Proposal for amendments to ECE/TRANS/WP.29/GRVA/2021/10

This document proposes minor corrections to GRVA/2021/10 in red ~~strickethrough~~ for deleted and red **bold** for new text.

**ACSF C – Case where the lateral movement is initiated automatically
(1 Step HMI)**

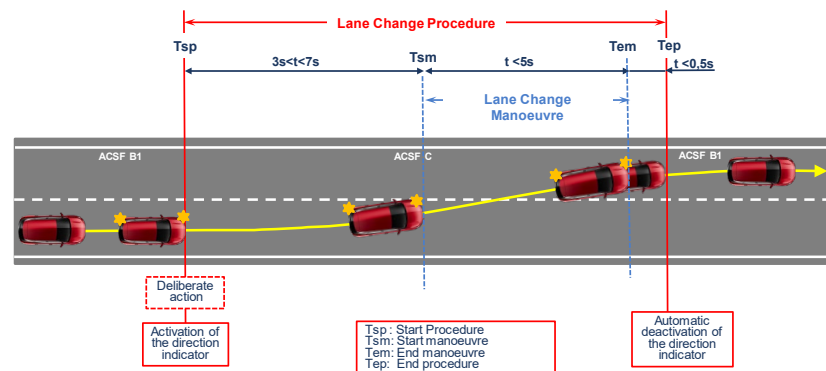
Paragraph 5.6.4.6.4.1., update illustration to prescribed timing:

In case of an automatic initiation the lane change manoeuvre shall commence between 3.0 seconds and ~~7.0~~ **7.0** seconds after the manual activation of the procedure as described in paragraph 5.6.4.6.2. and shown in the Figure below. **The manoeuvre shall commence at the earliest opportunity if the situation is not deemed critical as defined in 5.6.4.7.**
